## GFA AIRWORTHINESS DIRECTIVE

**TYPE AFFECTED:** DG-100 Series sailplanes TCDS LBA 301

**SUBJECT:** Flight Controls, Inspection / Modification:- Elevator Control Bearing Stand.

Technical note  
No. 301/26

**Part A: Inspection of the elevator control bearing stand RU19**

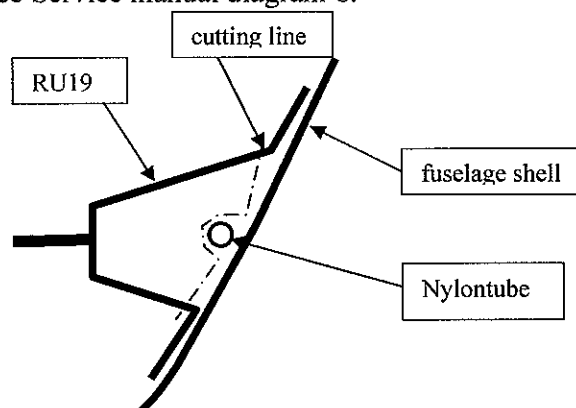
1. Remove the left baggage compartment floor.
2. Remove nut and washer which fix the elevator control bellcrank St9/1 (see Service manual diagram 8). Move bellcrank and the 2 washers between bellcrank and bearing stand min. 20 mm (0.8 in.) away from the stand.
3. Check the face of the bearing stand for cracks or white areas. Use a powerful torch.
4. If any damage was detected the bearing stand must be replaced prior to next take-off see Part B.
5. Otherwise the DG-100 may be operated up to the due date of instruction 3 of TN301/26 (=Part B).
6. Reinstall the bellcrank, use a new self locking nut M6DIN985-8 zn.
7. Reinstall the left baggage compartment floor.

Material: 1 self locking nut M6DIN985-8 zn
